In re Application of:)
Shinya KONDOH)
Serial No.: 09/981,791) Group Art Unit: 2673
Filed: October 19, 2001) Examiner: A. Mengistu
For: ANTIFERROELECTRIC LIQUID)
CRYSTAL LIQUID DISPLAY AND)
METHOD OF DRIVING THE SAME)

REQUEST FOR APPROVAL OF DRAWING CHANGE

Fig.7

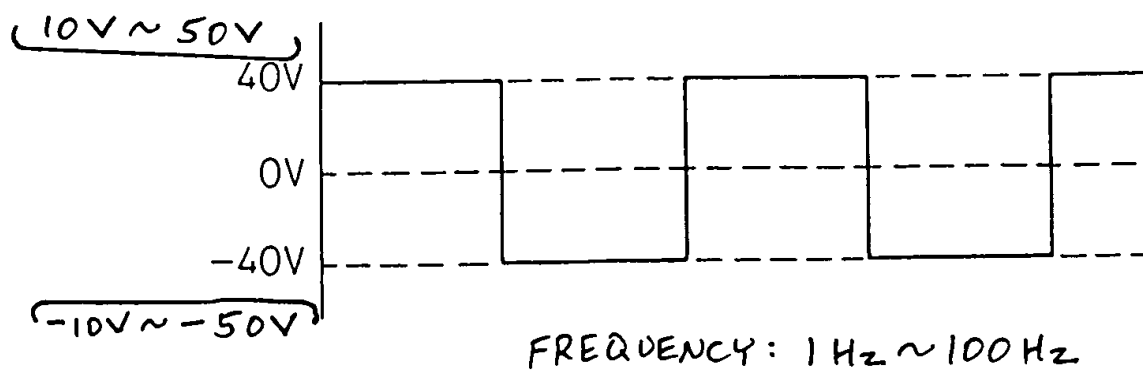
Subject to the approval of the Examiner, it is respectfully requested that Fig. 7 in the above-captioned application be amended to include labels for the frequency range and the maximum/minimum voltage values. The changes are indicated in red on the attached copy of the originally filed drawing sheet.
